Entergy Nuclear Operations, Inc.
Pilgrim Nuclear Power Station
600 Rocky Hill Road
Plymouth, MA 02360

Proposed Change to Applicability of Pilgrim's Pressure-Temperature Curves as Described in Technical Specification Figures 3.6.1, 3.6.2, and 3.6.3, Revision 1

LETTER NUMBER: 2.07.006

PROPOSED TECHNICAL SPECIFICATIONS CHANGES (MARK-UP)

FIGURE 3.6.1
Pilgrim Reactor Pressure Vessel Pressure-Temperature
Limits for Hydrostatic Leak Tests
The curve applies through Operating Cycle 16

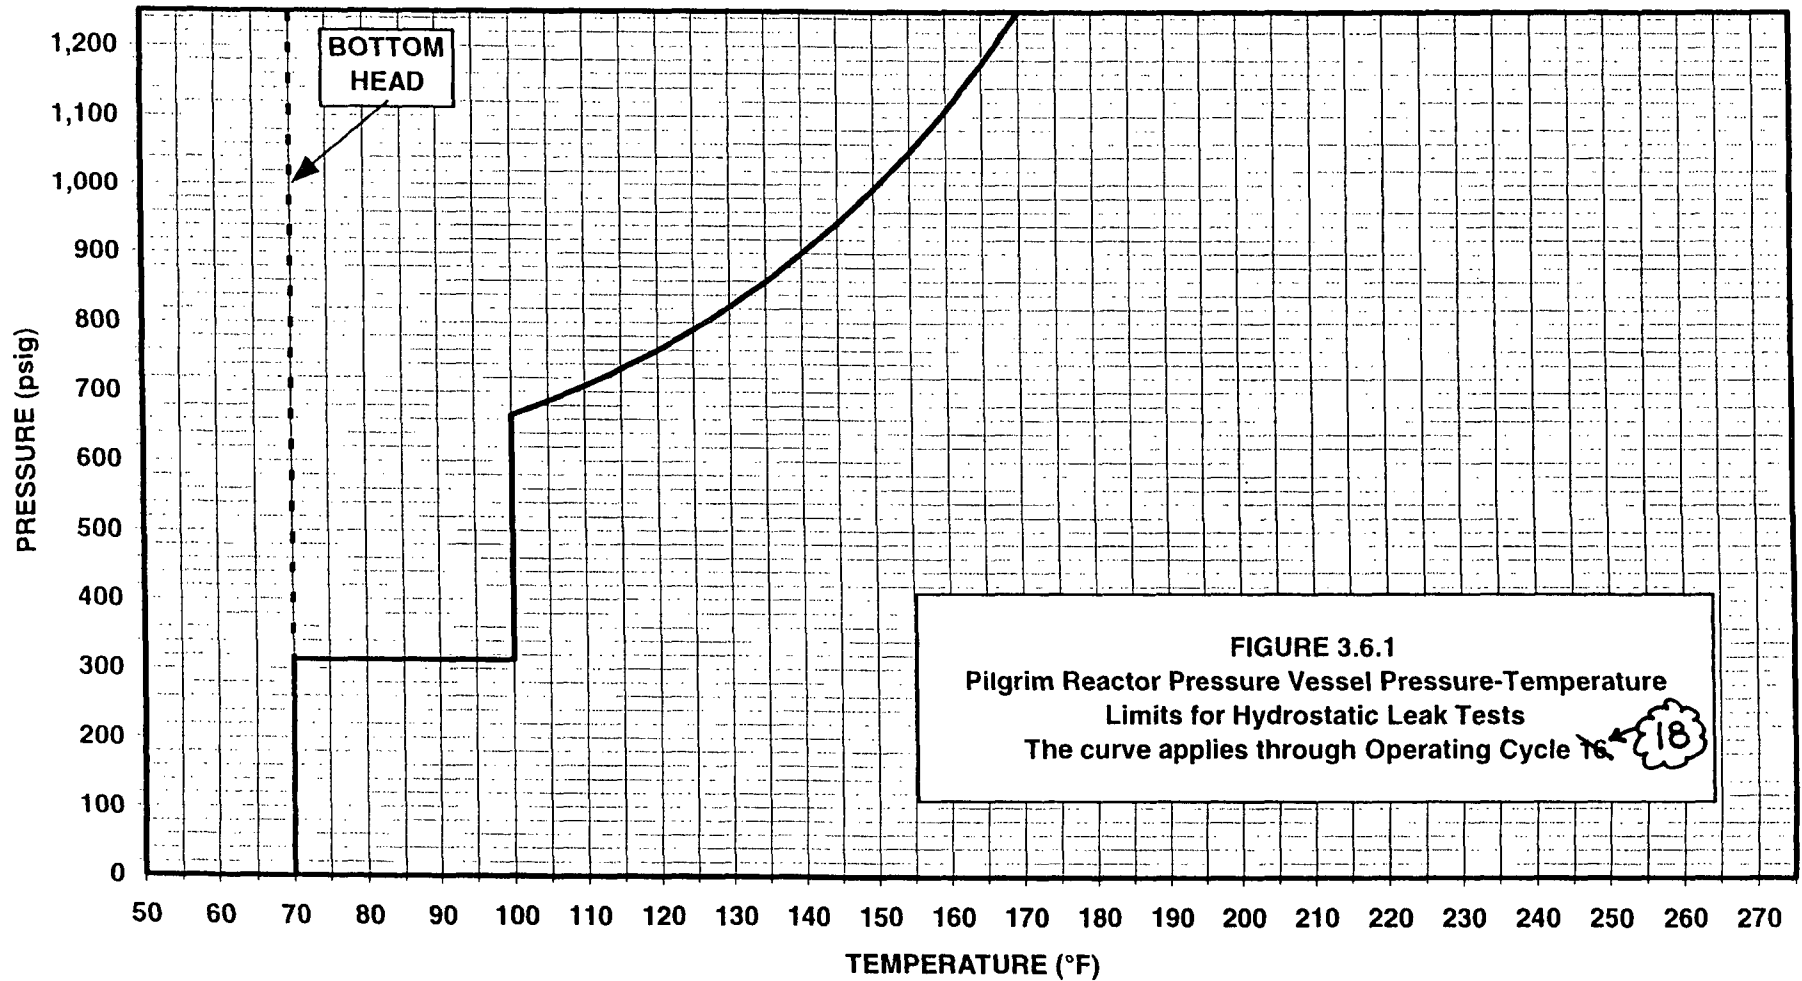
18

“The curve applies through Operating Cycle 18.”

PILGRIM REACTOR VESSEL PRESSURE-TEMPERATURE LIMITS
SUBCRITICAL HEATUP AND COOLDOWN

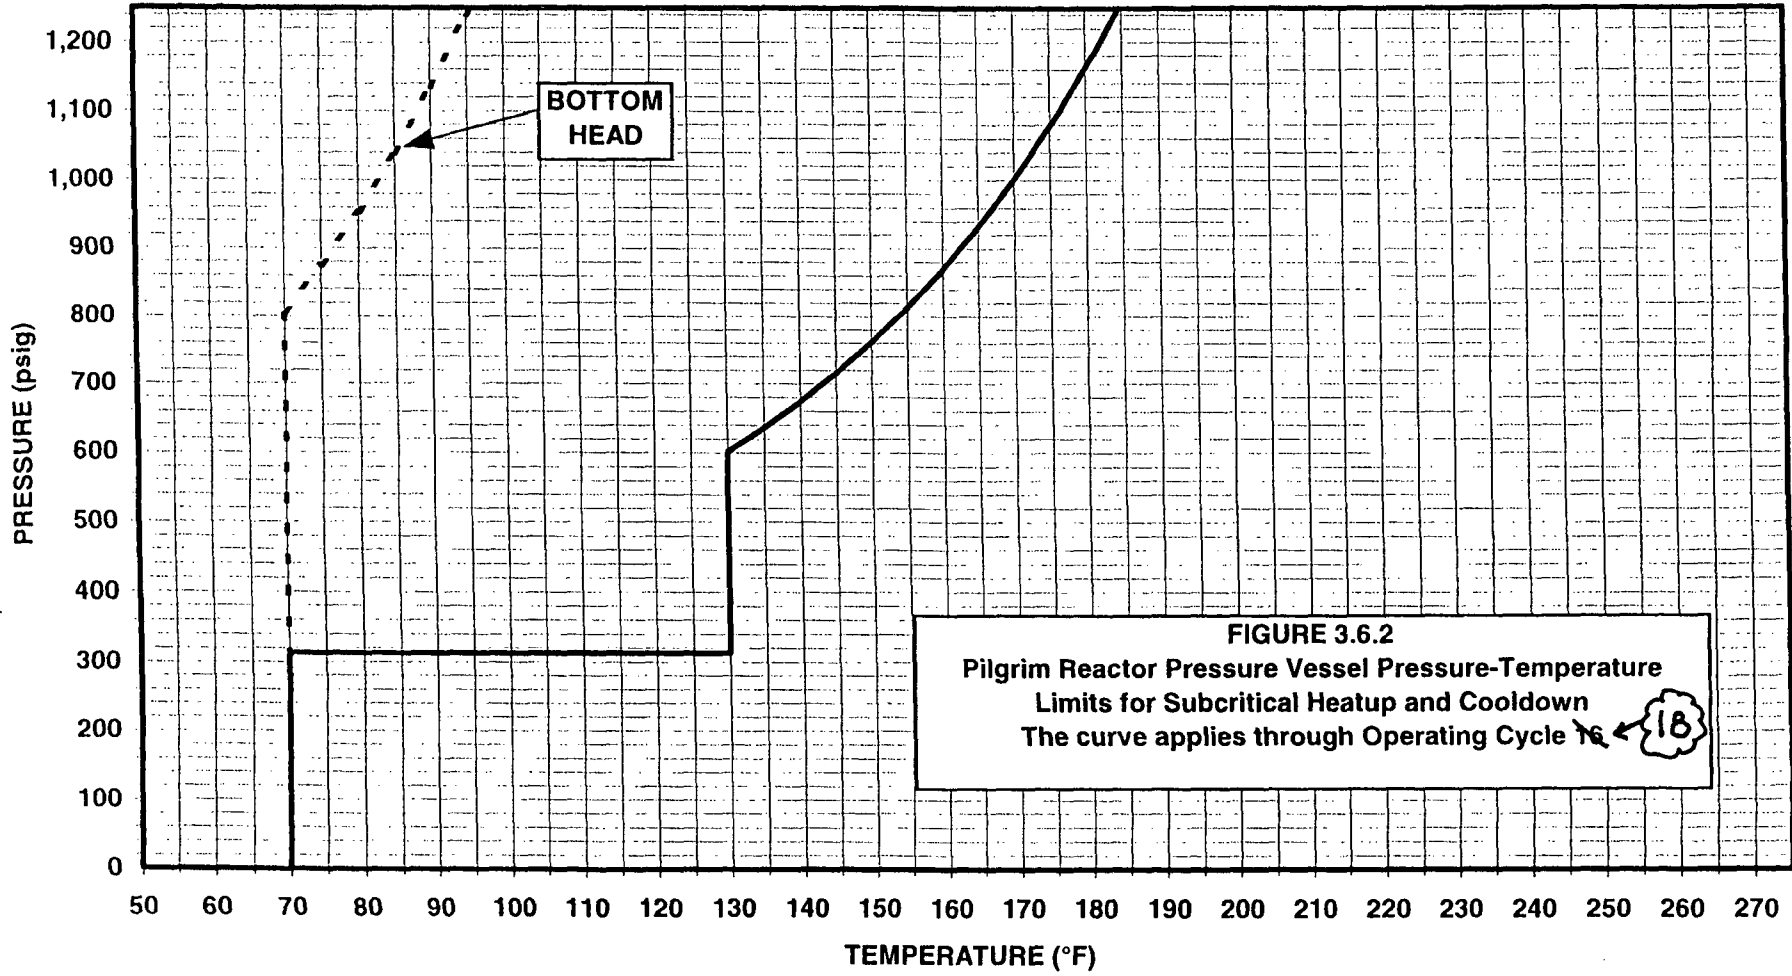
Currently, the title blocks for Figures 3.6.1, 3.6.2, and 3.6.3 contain, in part, the words:

“The curve applies through Operating Cycle 16.”
